**MEMORANDUM**

**TO:** District of Columbia Zoning Commission  
**FROM:** *JL for* Jennifer Steingasser, Deputy Director  
**DATE:** December 31, 2012  
**SUBJECT:** **Public Hearing Report** for ZC #09-08B, Dance Place  
Second Stage Planned Unit Development

### **DC Water Email**

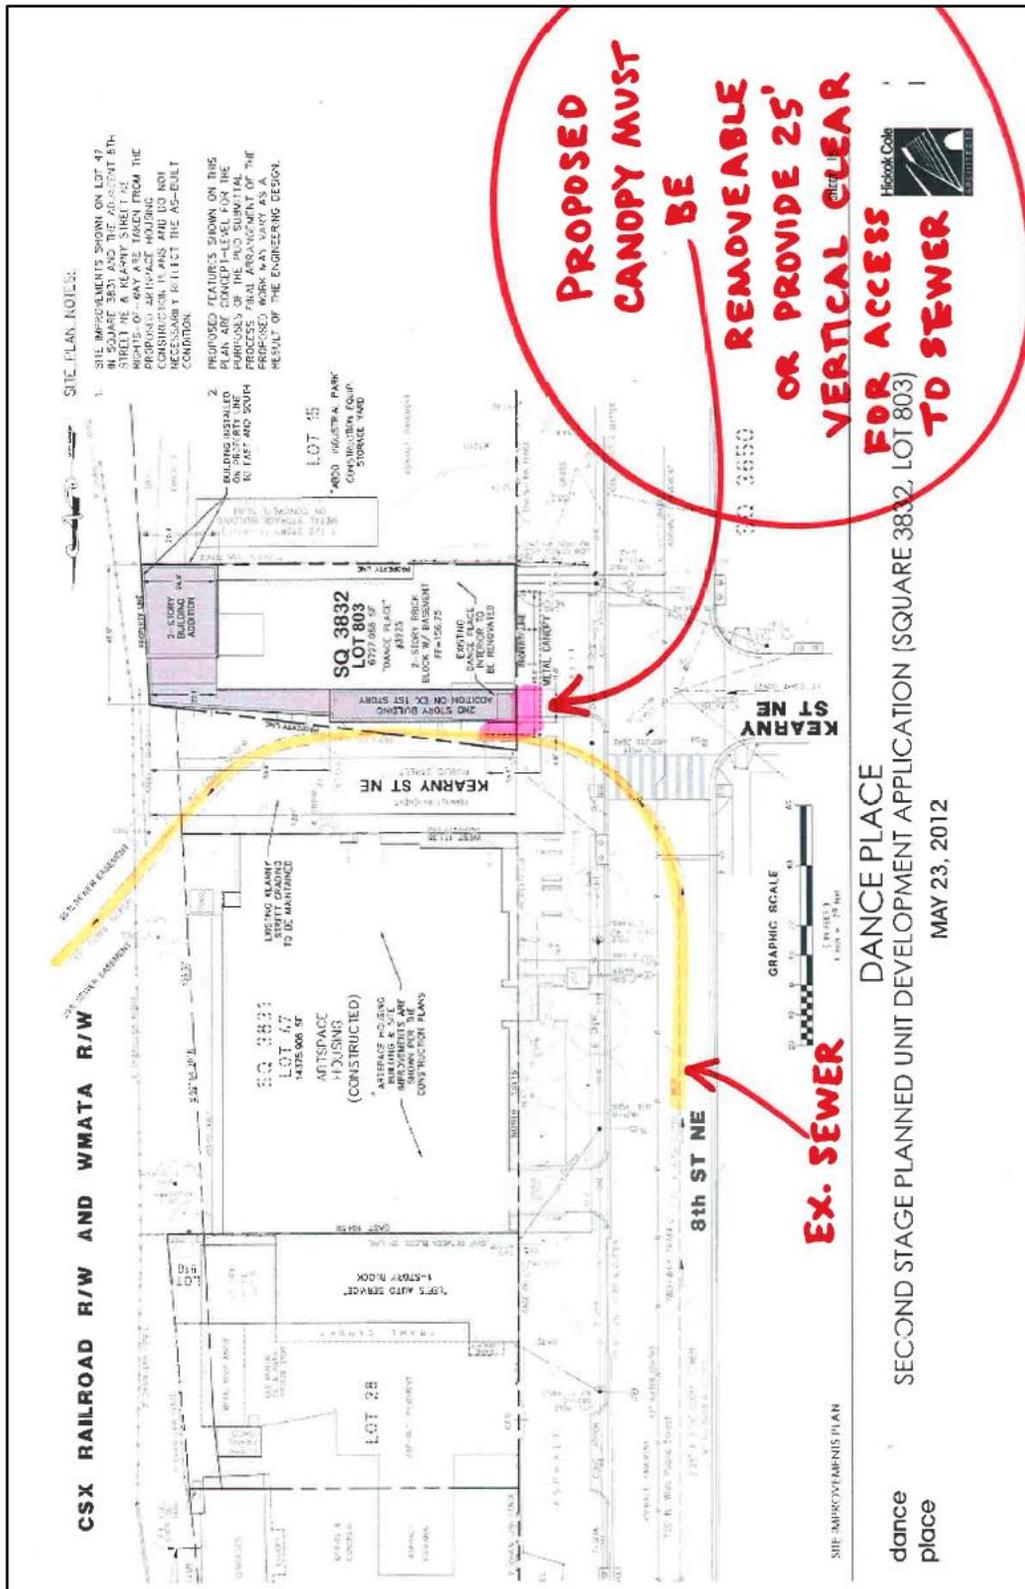
*With regard to water infrastructure abutting Square 3832, Lot 803, there is an existing 8-inch cast iron water main (constructed in 1941) in 8<sup>th</sup> Street NE – on the south side of the Kearny Street NE intersection. There is an existing 12-inch ductile iron water main (constructed in 1941) in 8<sup>th</sup> Street NE – on the north side of the Kearny Street NE intersection. These water mains are available for new connections.*

*With regard to sewer infrastructure abutting Square 3832, Lot 803, the project site is located in an area with a combined sewer network along 8<sup>th</sup> Street NE and Kearny Street NE. All proposed sanitary and storm sewer services must be connected to the combined sewer main. There is an existing 2.5' x 3.75' cast in place combined sewer main (constructed in 1896) located approximately four (4) feet from the existing/proposed northern building face. This combined sewer main is available for new sanitary sewer and storm service connections. The structural integrity of this existing, large-diameter sewer should be verified and monitored before, during, and after project construction. Pile driving in the vicinity of the 2.5' x 3.75' combined sewer main may be problematic. NOTE: The proposed canopy on the north side of the proposed building creates an unacceptable conflict for DC Water. The proposed canopy must be removable/retractable or provide a minimum of 25' vertical clearance so as to allow access to the existing 2.5' x 3.75' combined sewer main. See attached exhibit.*

*The information above describes the existing infrastructure in the vicinity of the project. A final determination of the ability of those lines to service this project can only be made after site development plans and supporting application documentation has been submitted to and reviewed by DC Water. If as a result of that review DC Water finds the existing water and sewer systems to be unsuitable for the proposed connections, the plans will not be approved. The applicant is advised that, under DC Water's infrastructure renewal program, priority is given to replacement of infrastructure that serves the most critical needs of our customers, as determined by DC Water. Any upgrades to the water and sewer systems that may be needed to accommodate this project are unlikely to be included in DC Water's renewal program in the immediate future. The applicant may at their option elect to replace or extend water and sewer, at their expense, to meet their project needs.*
